March 20, 2018  
15045

**Third Party Review of the Rezoning Petition in Northern Aroostook County, Fish River Chain of Lakes Concept Plan**

### SLOPE EVALUATION OF FISH RIVER CHAIN OF LAKES DEVELOPMENT AREAS

LOCATION: LONG LAKE B	FOR: J.D. IRVING LIMITED	INFORMATION: 2011 LIDAR DERIVED DATA PROVIDED BY J.D. IRVING, LIMITED
--------------------------	-----------------------------	--

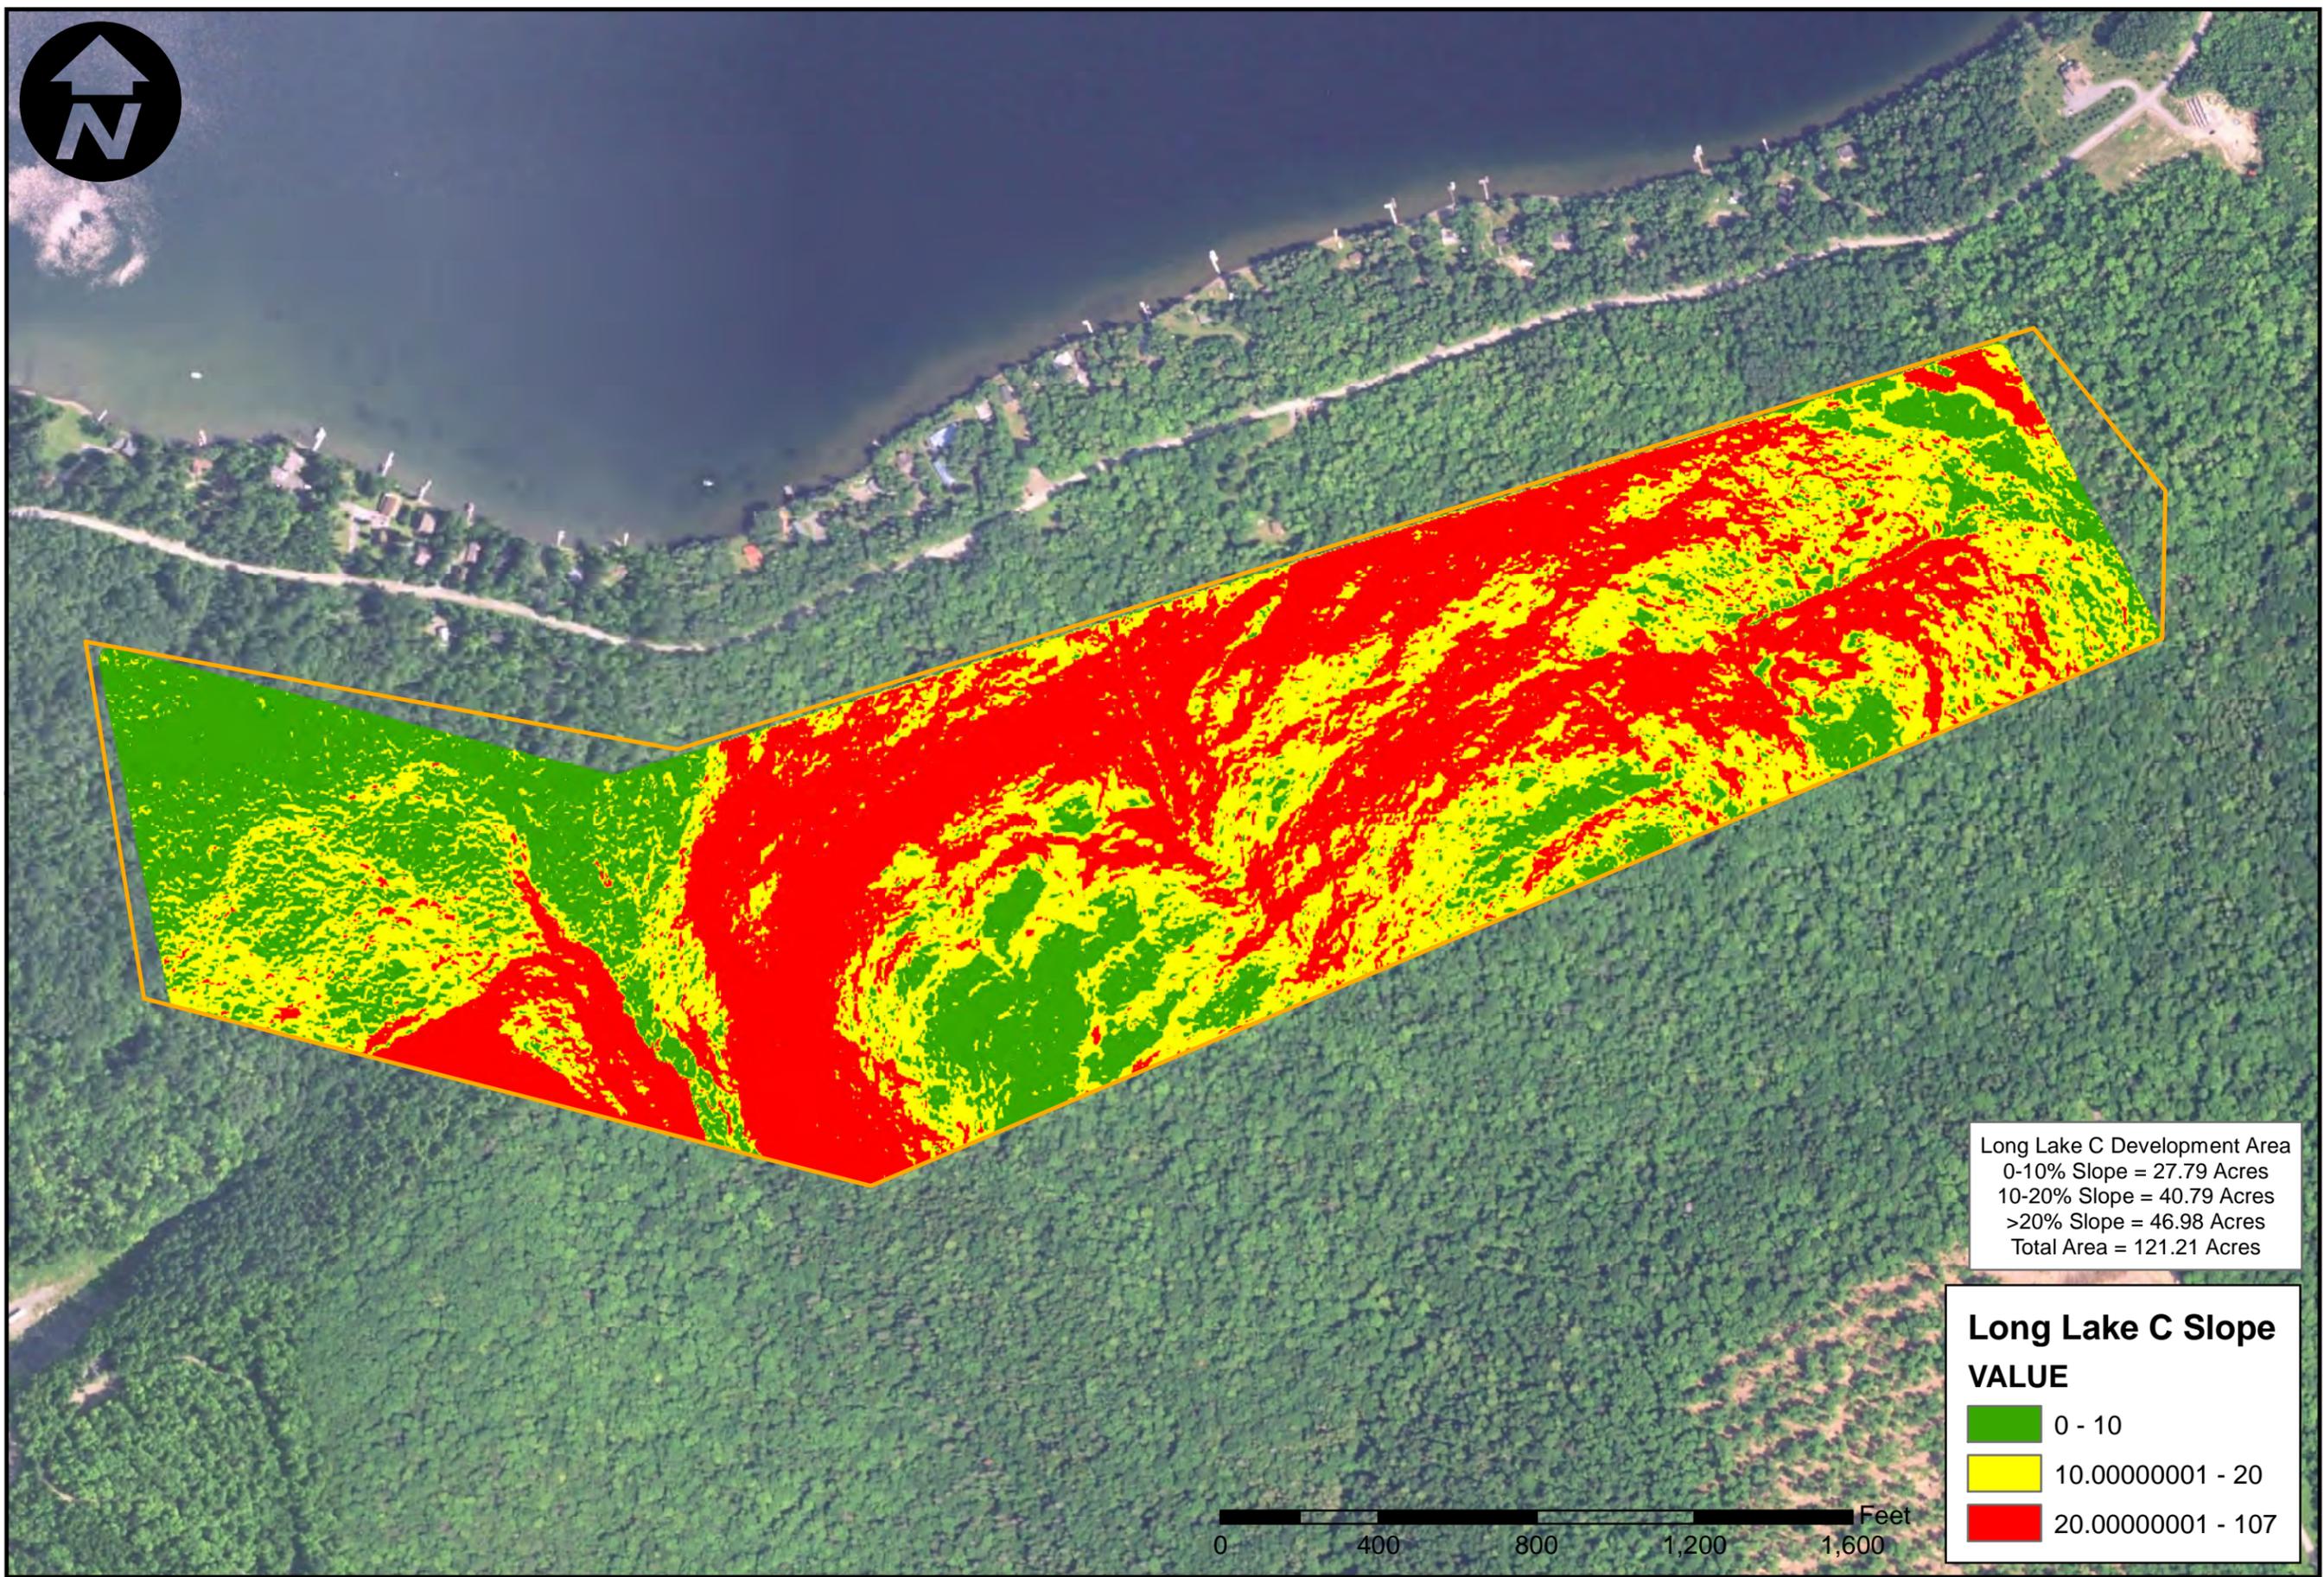
1. Slope Analysis: The slope analysis indicates approximately 11 acres of the development area contains slopes greater than 20 percent and are considered unsuitable for development. The greater than 20% slopes are generally associated with linear slope. Slopes 0-10% slopes encompass approximately 17 acres. Limited suitability slopes (10 to 20% slopes) encompass approximately 27 acres of the project area. The slope assessments suggest the development area is partially suitable for the intended purposes noting that the slopes greater than 20% are not considered suitable for development due to limitations for wastewater disposal systems, erosion and drainage control considerations and slope stability.

The Lidar terrain mapping suggest a linear feature of slopes in excess of 20% runs parallel to the primary access road between the existing camps and proposed development area. This will present a physical barrier impacting the ability to access the westerly portion of the property. As a result, access to the some of the developable land maybe difficult or not practicable due to physical constraints. Therefore, while the net developable area of 2.1 acres/unit appears reasonable, we recommend further evaluation and confirmation the westerly land area can be reasonably accessed.

2. The soils in this development area (NRCS Mapping) include HoB/HoC (Howland gravelly loam) and ThD (Thorndike channery silt loam) soil series. The ThD soils are considered unsuitable due to steep slopes and expected susceptibility to erosion when disturbed. ThD soils are also shallow to bedrock which serves as a restrictive layer at 11 to 23 inches. The soils in this project area range from a gravelly loam to a silt-loam and are moderately well to somewhat excessively drained with a water table over 16 inches and considered a hydrologic group "C/D" and "D" soils. Theses soils present some limitation depending on slope and location of the restrictive layer along with higher erosion potential and stormwater management considerations.

Our assessment suggests that the project area and number of planned units (15) yields an effective net density of 2.1 acres/unit (Please refer to the development matrix analysis appended to this report). This assessment includes deductions for slopes over 20% and allowing for 25% of the 10% to 20% (limited suitability slopes) to be considered not suitable.

While this net density appears reasonable, the physical location of the mapped feature represents potential restrictions in accessing the development land and will require special attention to the management stormwater to meet Maine DEP chapter 500 regulations. Additionally, the northerly area of the project site appears to be nearly all slopes in excess of 20% and therefore not suitable for development.

In conclusion, we recommend further consideration of this development parcel as it pertains to accessing the developable areas through the steep slope areas and the developability of the northerly portion of the site since this area appears to be generally consumed by slopes in excess of 20%.
